Figure 11–50.
Heating of a typical floor
beam (W24 x 55) subject
to an ASTM E 119
temperature profile for
different SFRM
thicknesses.

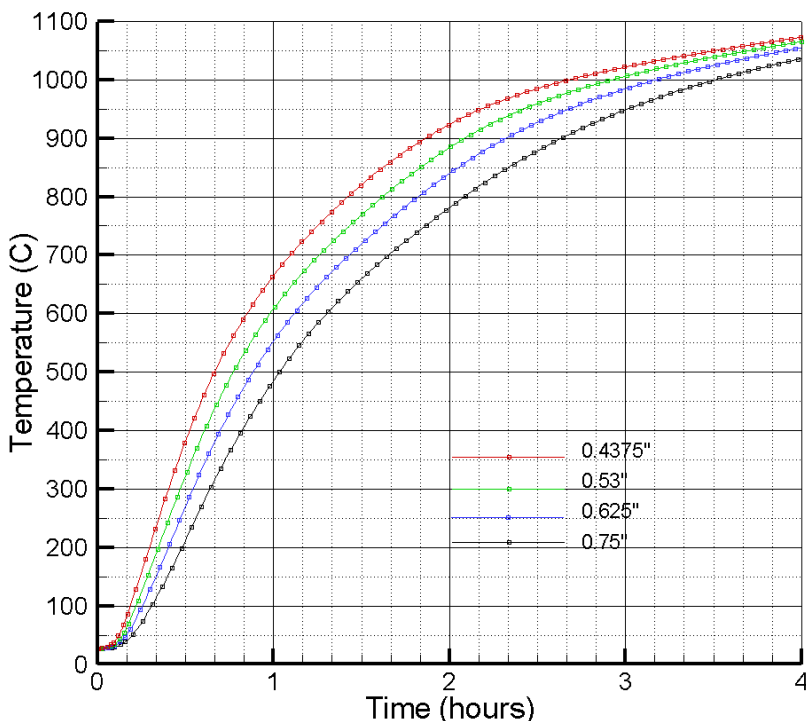
When the steel beam reached 600 °C under the ASTM E 119 temperature curve, the additional protection provided by increasing the SFRM thickness to 0.625 in. (5/8 in.) or 0.75 in. (3/4 in.) was approximately 8 min to 15 min, as shown in Figure 11–50. The ASTM E 119 tests for floors and roofs allow the temperature criteria to apply for one half of the classification of the assembly or 1 h, whichever is greater. For instance, for a 2 h fire rating for a floor assembly, the floor beams cannot exceed the temperature criteria of 1300 °F (704 °C) at any one location or 1100 °F (593 °C) for the average temperature at a cross section for 1 h.
